MID-STATION (X-ARM) INTEGRATED LAYOUT (HANFORD)

CAD FILE: D980224-01.dwg SIZE: D DWG. NO.: D980224-01-E

D980224-README

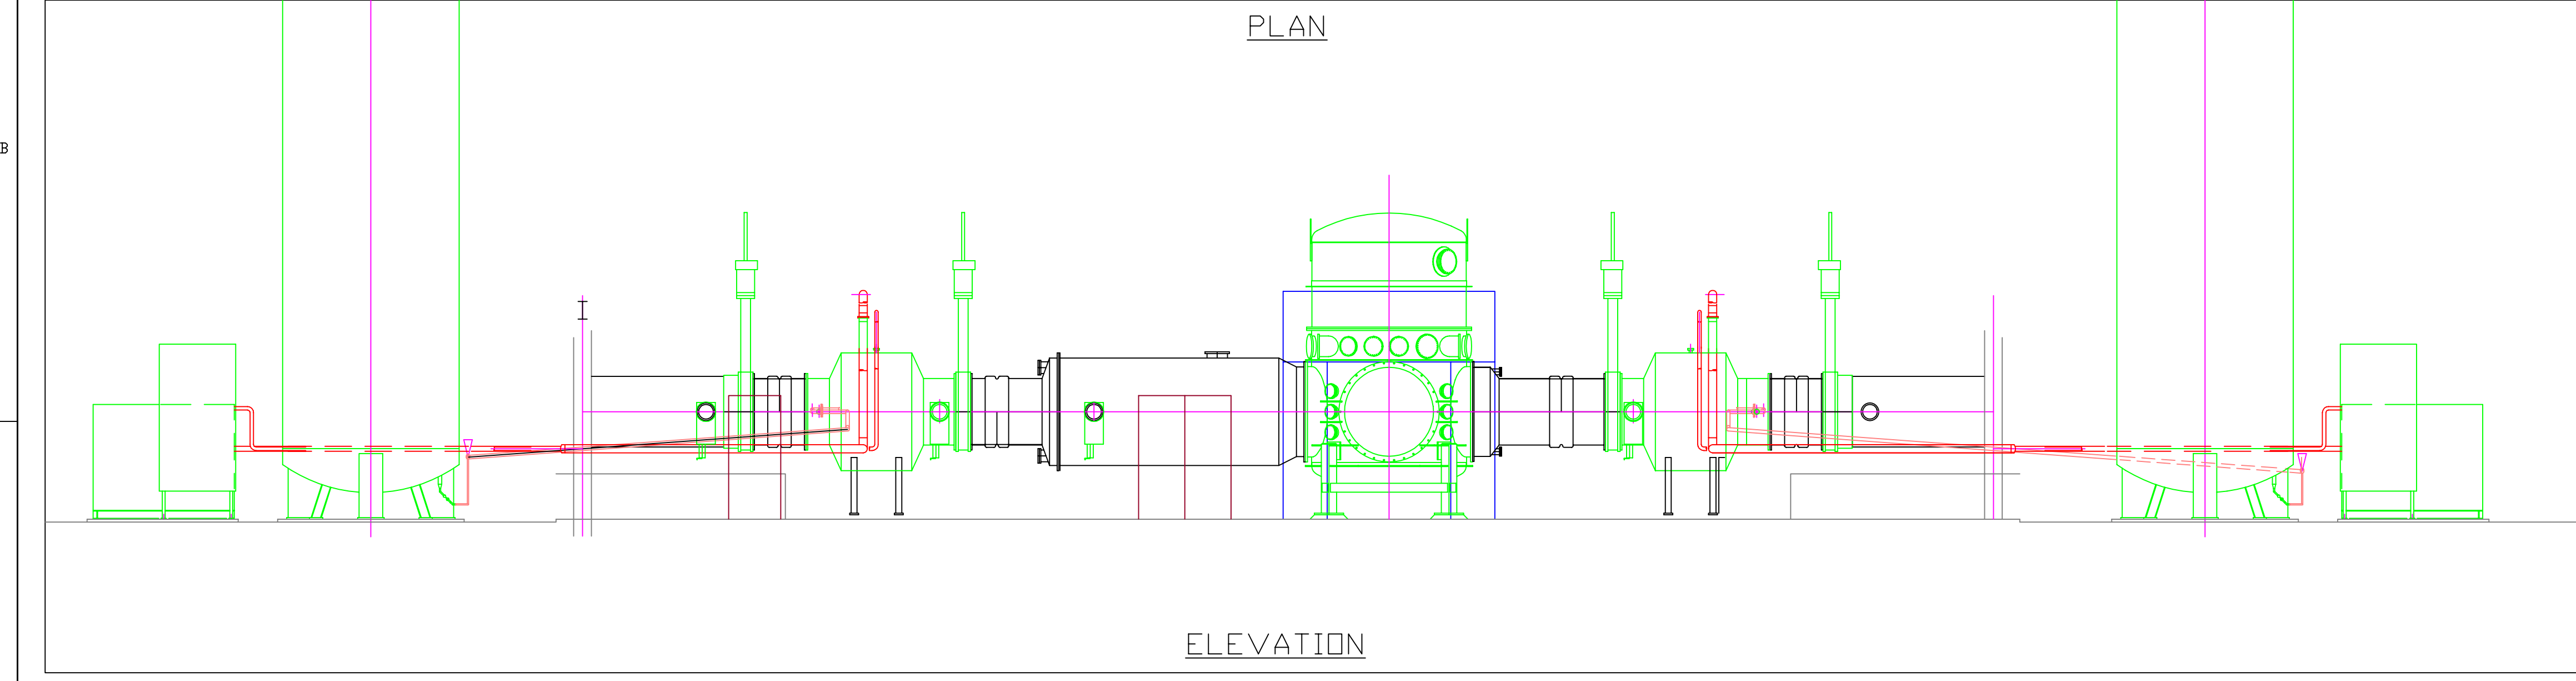
Added rack, chamber, & electrical designations.
